ADDENDUM NO. 2

Kau Water System Improvements – Phase 1

IFB No.: IFB-20-HHL-019

DWG. NO.
S-11
SHEET 39 OF 54

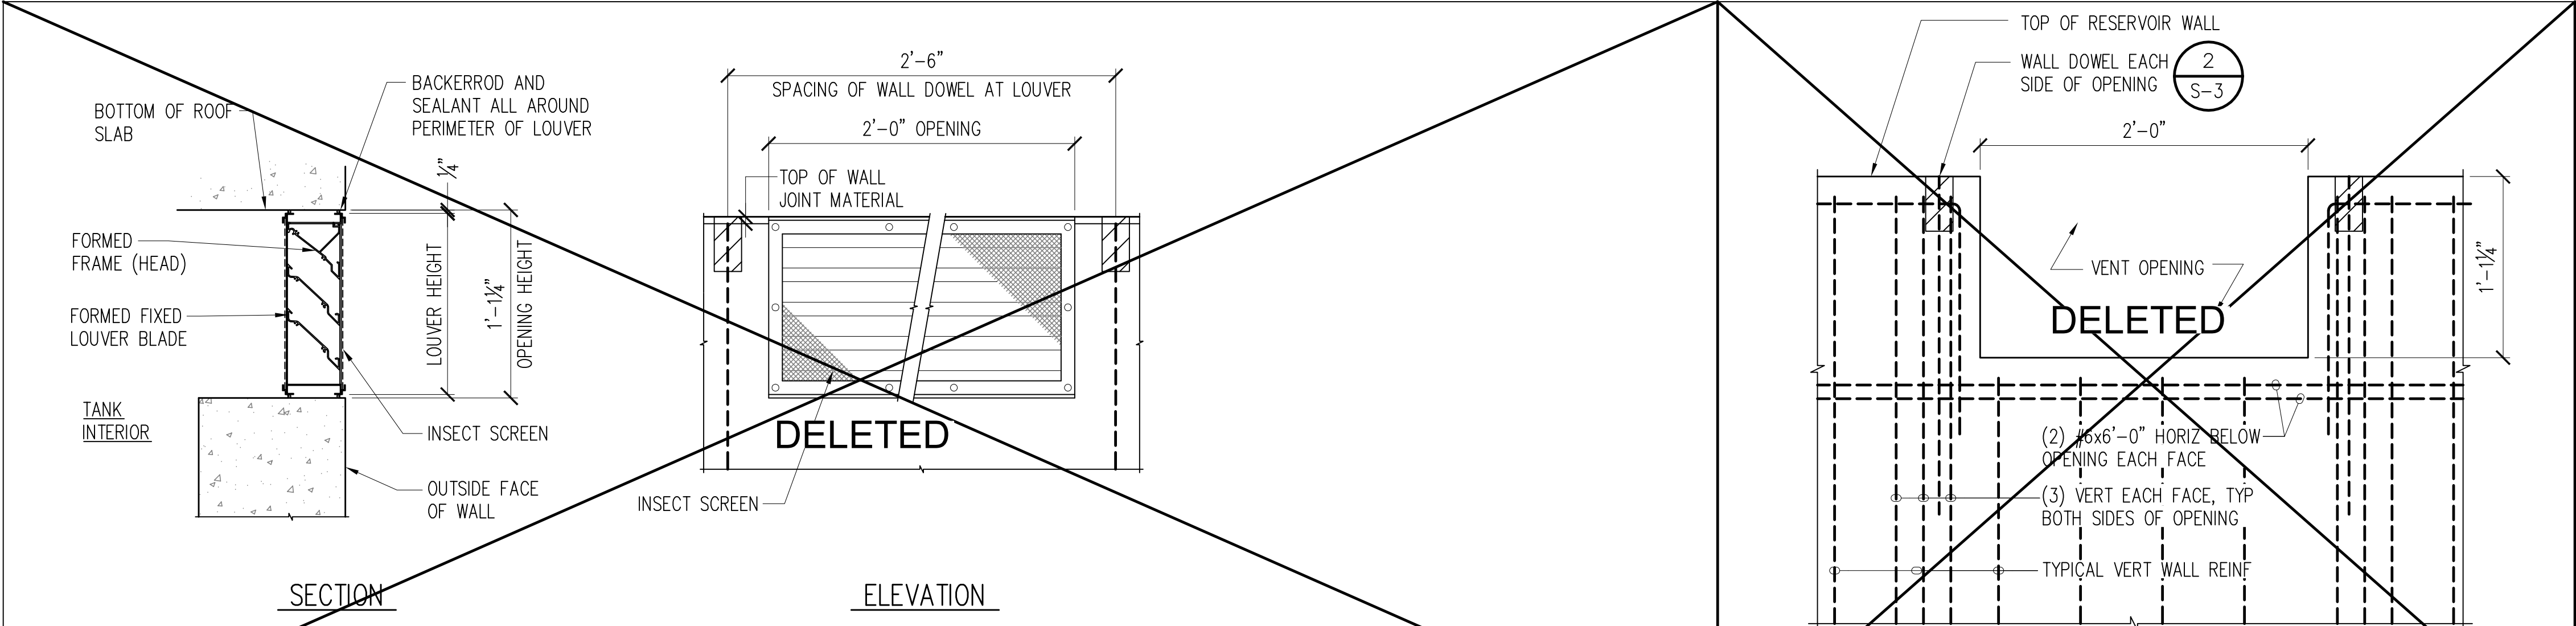
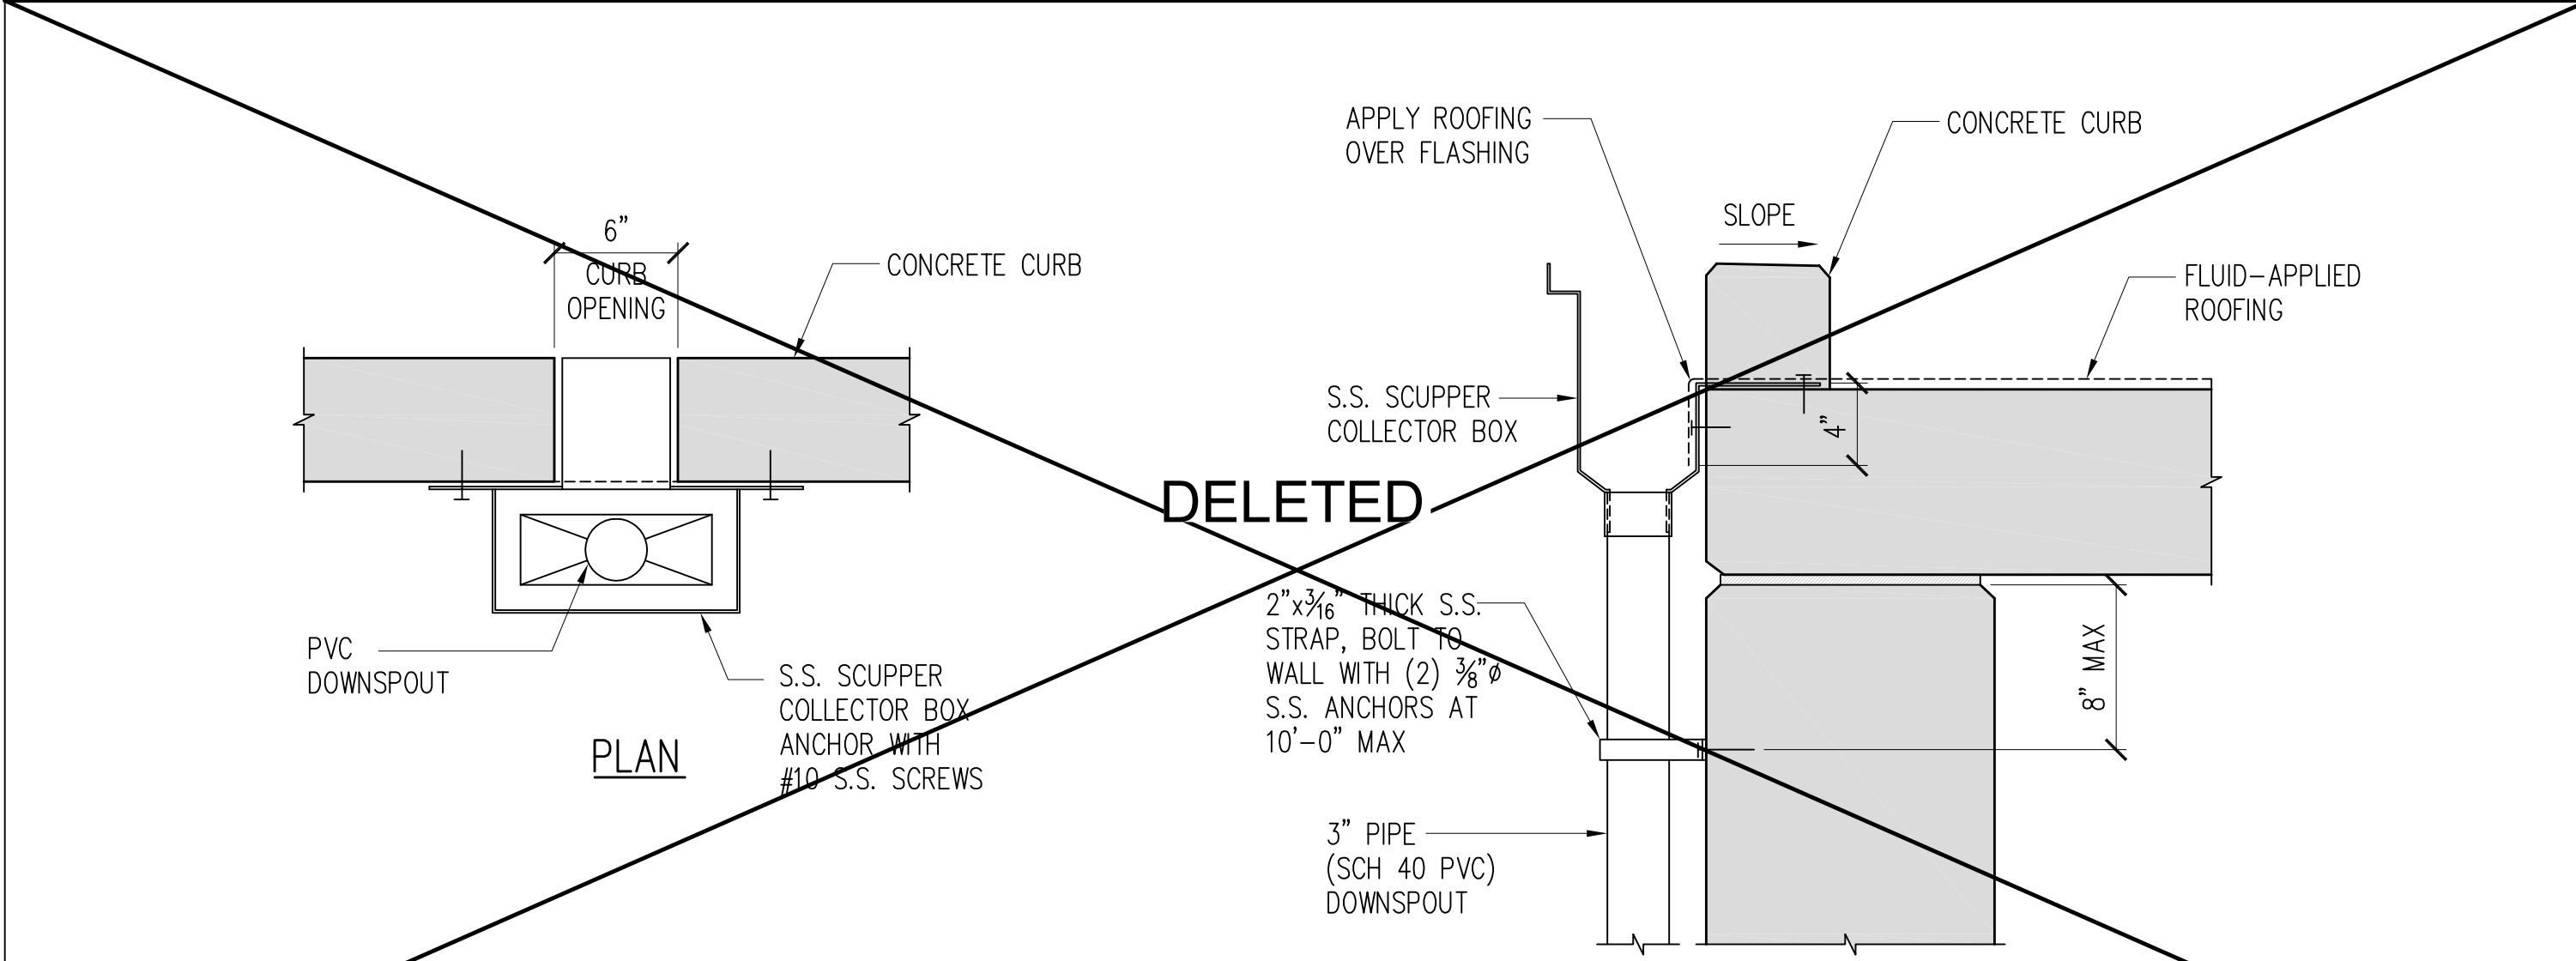
23. PLANS: SHEET S-11 – Revised sheet title to “RESERVOIR VENTILATOR DETAIL.”
24. PLANS: SHEET S-11 – Deleted wall louver details 1 and 2/S-11; Deleted 3/S-11 – SCUPPER COLLECTOR BOX DETAIL; Added detail 4/S-11 – ROOF VENTILATOR DETAIL.

EXTERIOR STAIR AND LANDING PLAN

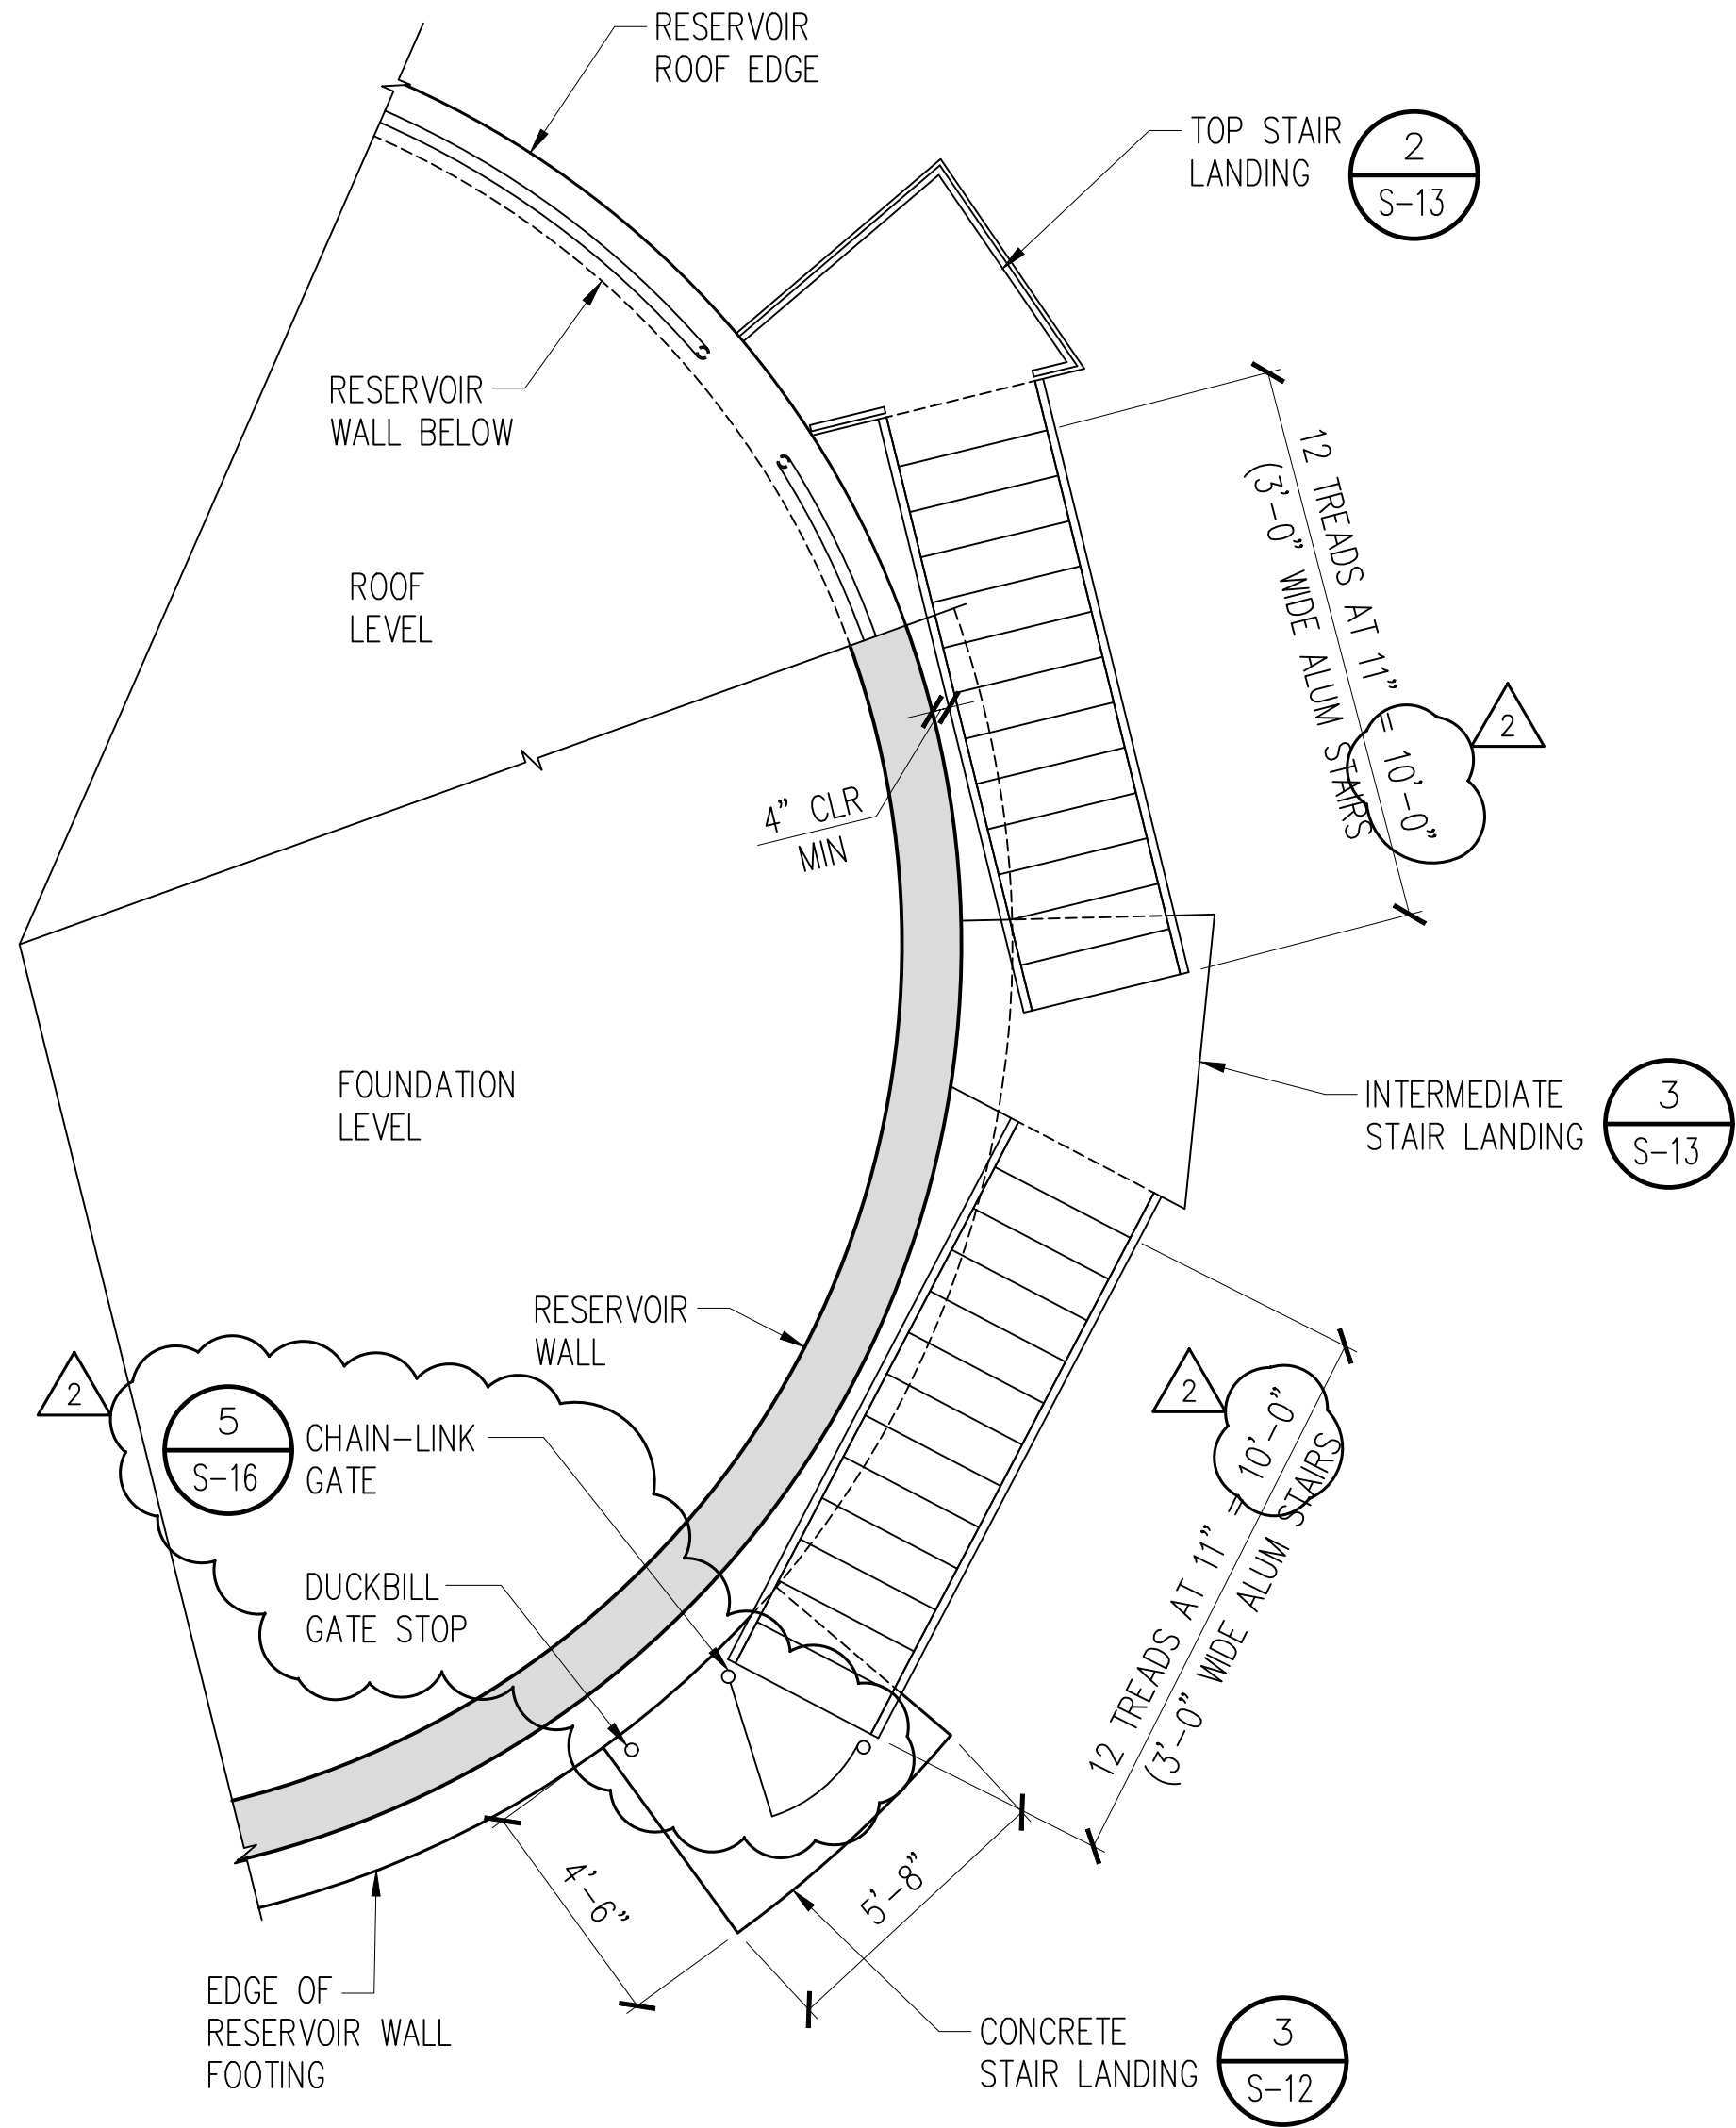
25. PLANS: DETAIL 1/S-12 – Revised stair tread total length dimensions; removed security fence enclosure; added chain-link gate and duckbill gate stop at bottom stair landing.

1 TYPICAL STAIR HANDRAIL & STRINGER ELEVATION
S-14 NOT TO SCALE

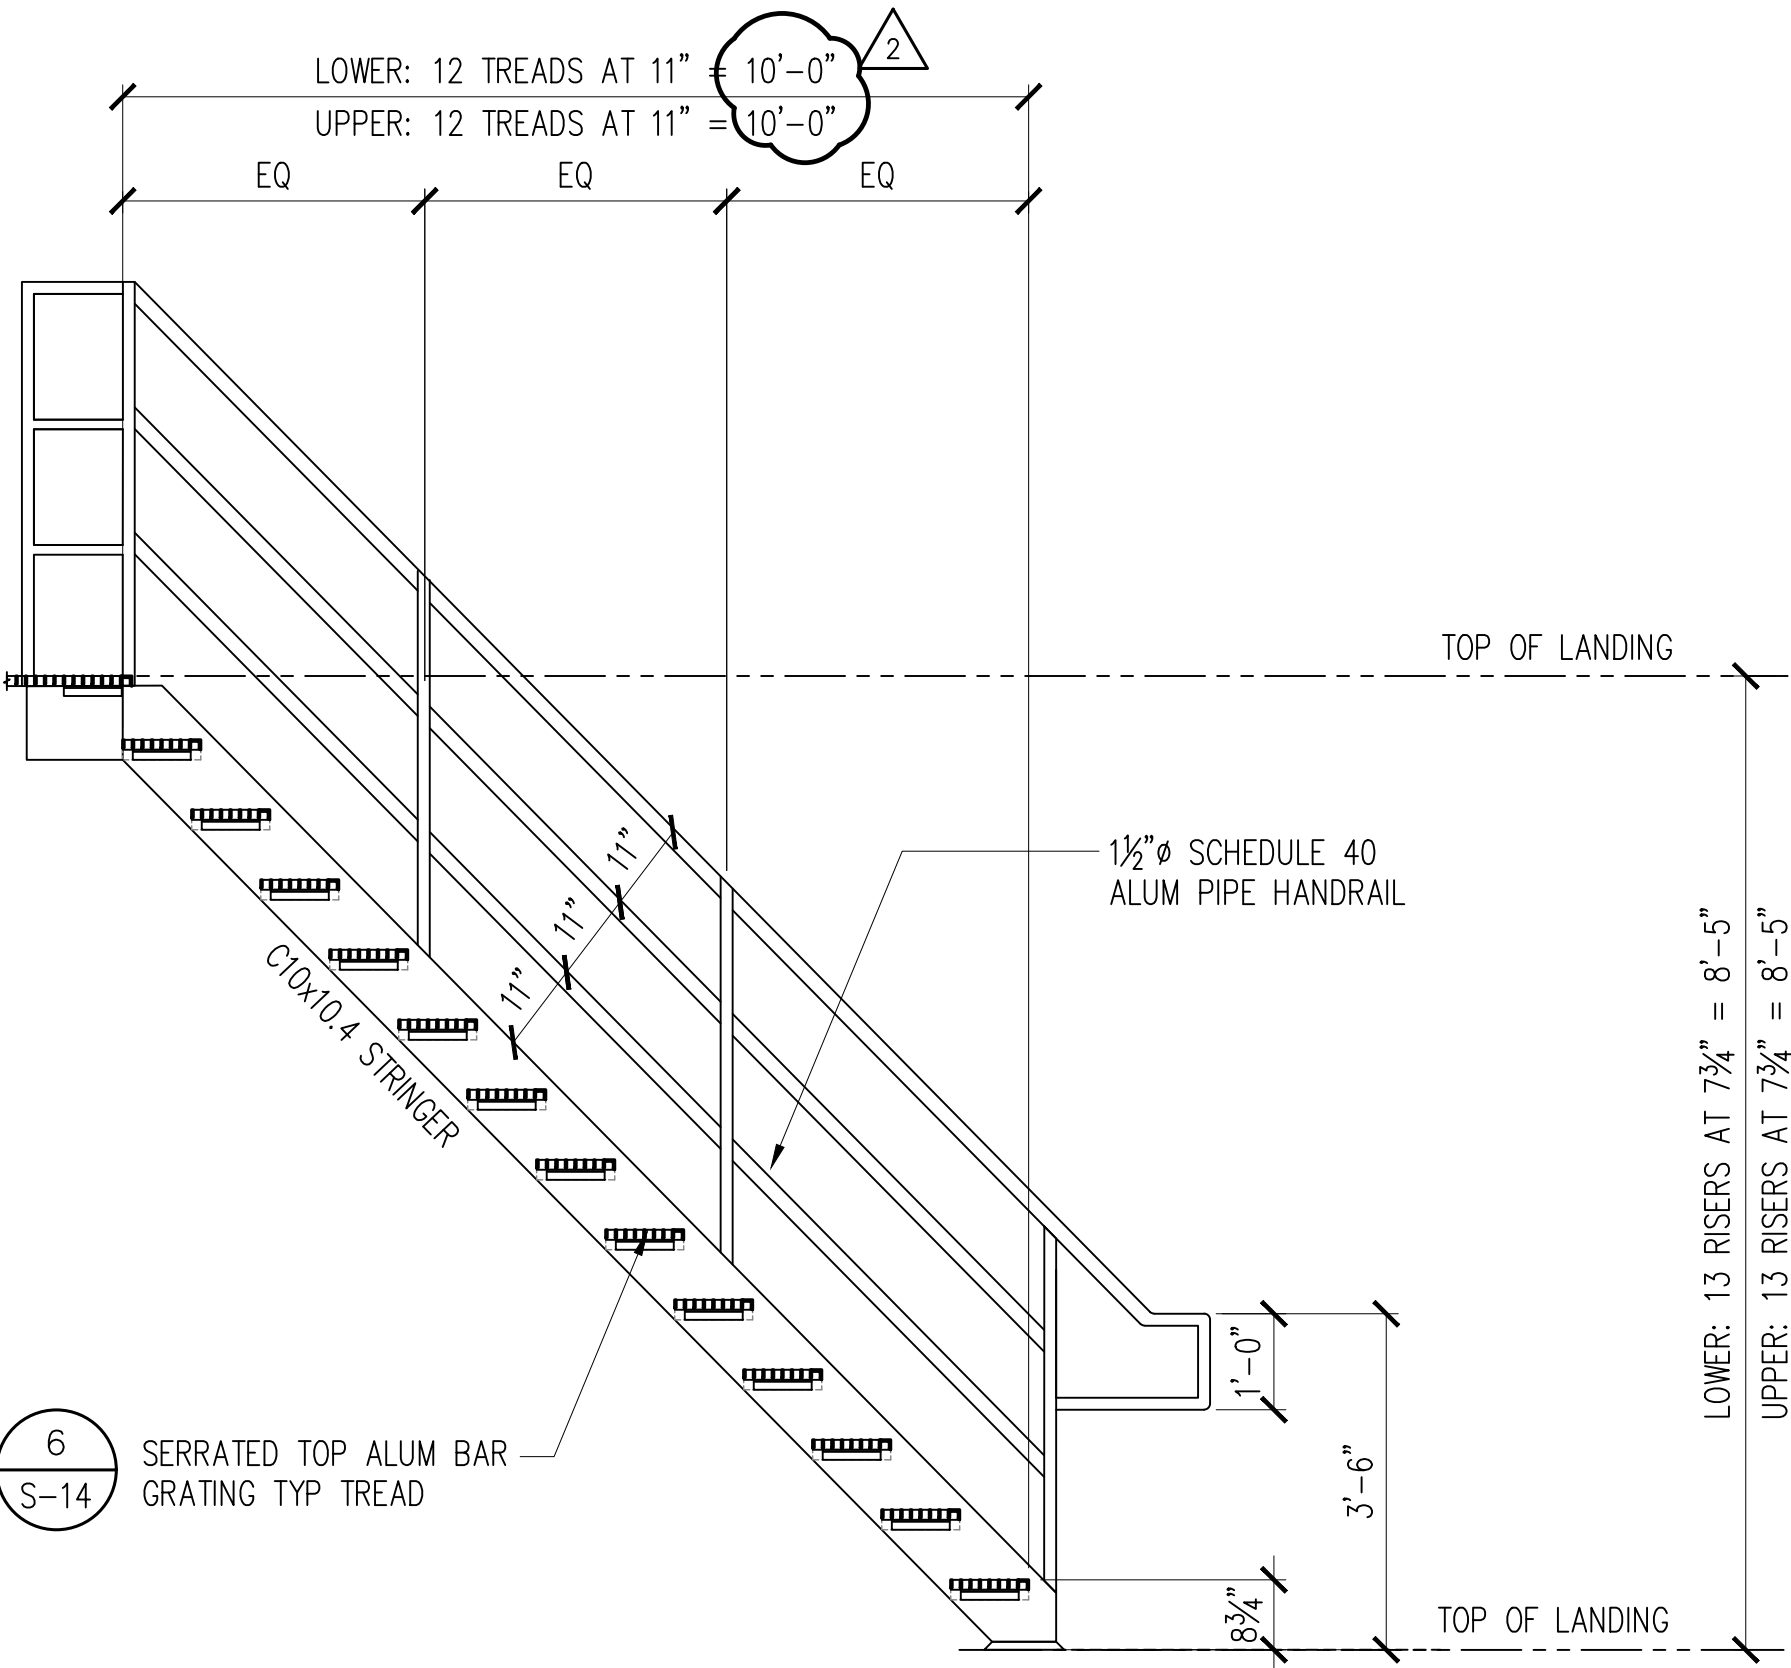
28. PLANS: DETAIL 3/S-13 – Removed security fence enclosure.
29. PLANS: DETAIL 1/S-14 – Revised upper and lower stair tread total length dimension.
30. PLANS: Deleted SHEET S-15 in its entirety.
